EAST ROSWELL LIBRARY
ADDENDUM NO. 03.1-3
APRIL 25, 2013

This Addendum No. 03.1-3 dated April 25, 2013 issued by Ajax Building Corporation of Georgia is hereby made part of Bid Package 03.1 – CONCRETE for the East Roswell Library. The changes and/or clarifications included in this Addendum shall be considered as part of the Bidding Documents and shall supersede, amend, add to, or subtract from those conditions included in the original Bidding Documents, including the Project Bid Package, Drawings, Specifications, previous Addenda, etc. This Addendum must be acknowledged in the space provided on the Proposal Form (included in Section II of the Bid Package). Failure to acknowledge this Addendum may subject Bidder to disqualification.

Receiver's Reply:
Piedmont Pipe Downspout - Model SO

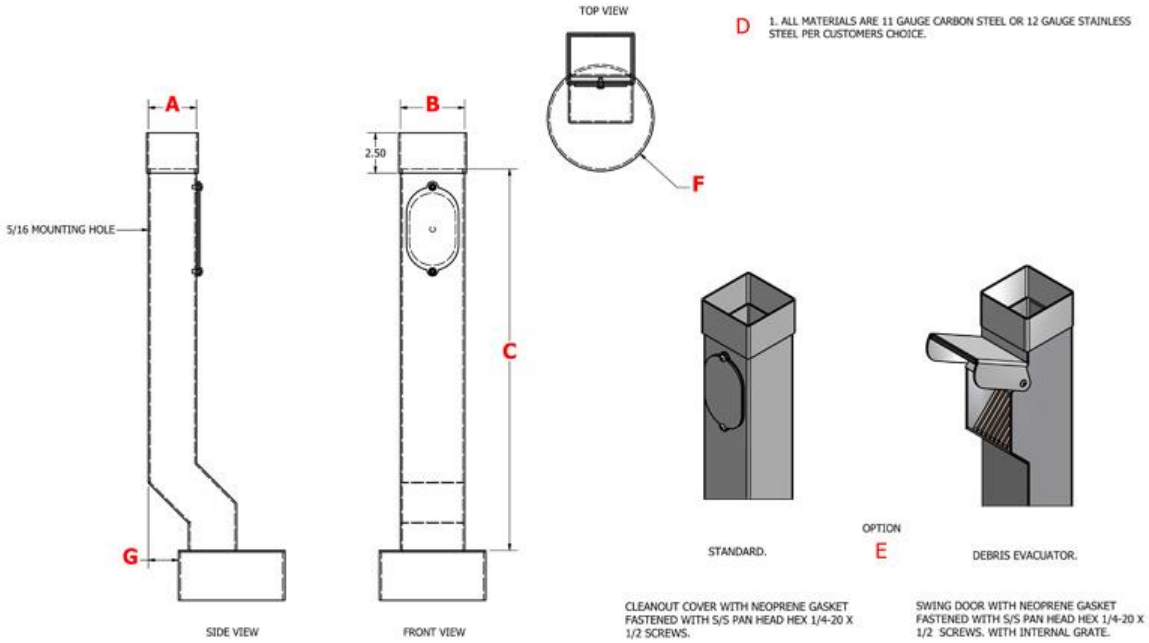
Please provide Body Length and Offset Size for downspout boots.

A: To Receive 8" Diameter OD Downspout
B: To Receive 8" Diameter OD Downspout
C: 24"
D: 304 Carbon Steel with Manufacturer's standard black finish
E: Standard Cleanout
F: To connect to 8" Storm drain
G: 4" off set
